# Work Order ID 113975

Item ID:	D412-664-203TRN	Accept	<b>*N900040100*</b>	Setup	Start	<b>*NS1*</b>
Revision ID:					Stop	<b>*NS2*</b>
Item Name:	Crosstube Turning Detail					
Start Date:	2/28/14	Start Qty:	1.00	<b>*1*</b>	Cust Item ID:	
Required Date:	3/14/14	Req'd Qty:	1.00	<b>*1*</b>	Customer:	
Reference:

<b>DART AEROSPACE LTD</b>	<b>Work Order:</b>	113975
<b>Description:</b> Crosstube Assembly (412 High Aft)	<b>Part Number:</b>	D412-664-243
<b>Inspection Dwg:</b> D412-664-243 Rev: E		Page 1 of 2

DRAWING NO. D412-664-243	TITLE CROSSTUBE ASS'Y (412 HI AFT)	REV. E	<b>DART AEROSPACE LTD ENGINEERING ORDER</b>		D.E.O. NO. D412-664-243-E-2	SHEET NO. SHEET 1 OF 1	SCALE NTS
DRAWN <i>qp</i>	CHECKED <i>ASS</i>	MFG. APPR. <i>ER</i>		APPROVED <i>MP</i>	DE APPR. <i>HA</i>		
DATE 11.09.07	DATE 11.09.19	DATE 11.09.19		DATE 11.09.19	DATE 11.09.19

**D412-664-243  
ASSEMBLY DETAIL**

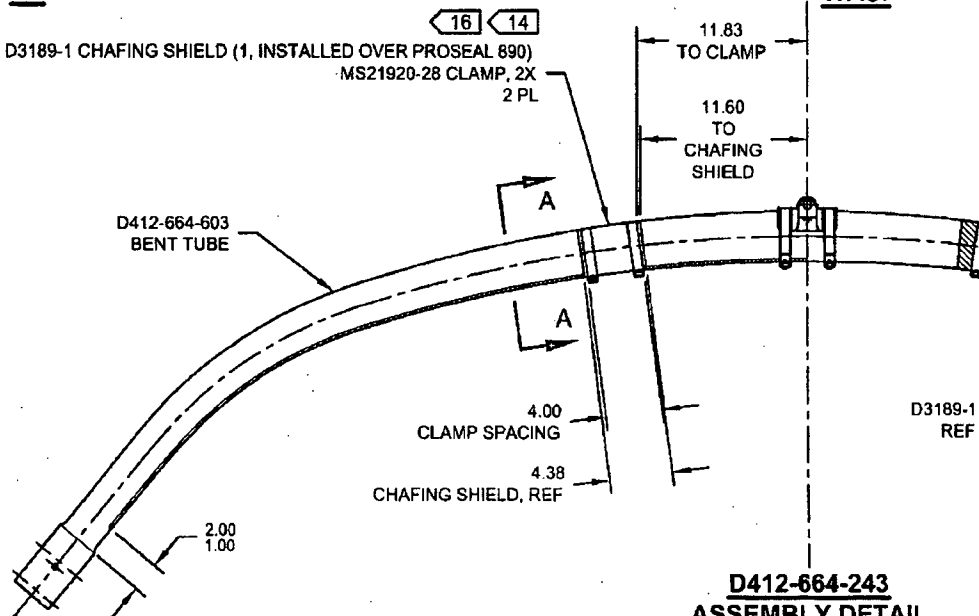
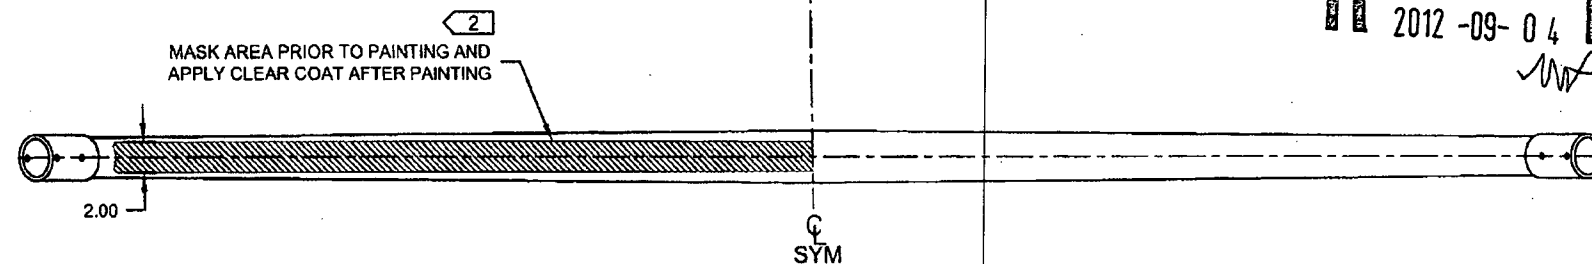
REMOVED ABRASION STRIP IN FAVOR OF A THIN LAYER OF PROSEAL 890. UPDATE INSTALLATION OF CHAFING SHIELDS AND REDUCE TORQUE TO 40-50 IN-LBS. THIS ENGINEERING ORDER SUPERCEDES DEO D412-664-243-E-1.

D3189-1 CHAFING SHIELD (1, INSTALLED OVER PROSEAL 890)  
MS21920-28 CLAMP, 2X  
2 PL

D2856-600-1009 ABRASION STRIP  
D3189-1 CHAFING SHIELD (1, INSTALLED OVER ABRASION STRIP)  
MS21920-28 CLAMP, 2X  
2 PL

MASK AREA PRIOR TO PAINTING AND  
APPLY CLEAR COAT AFTER PAINTING
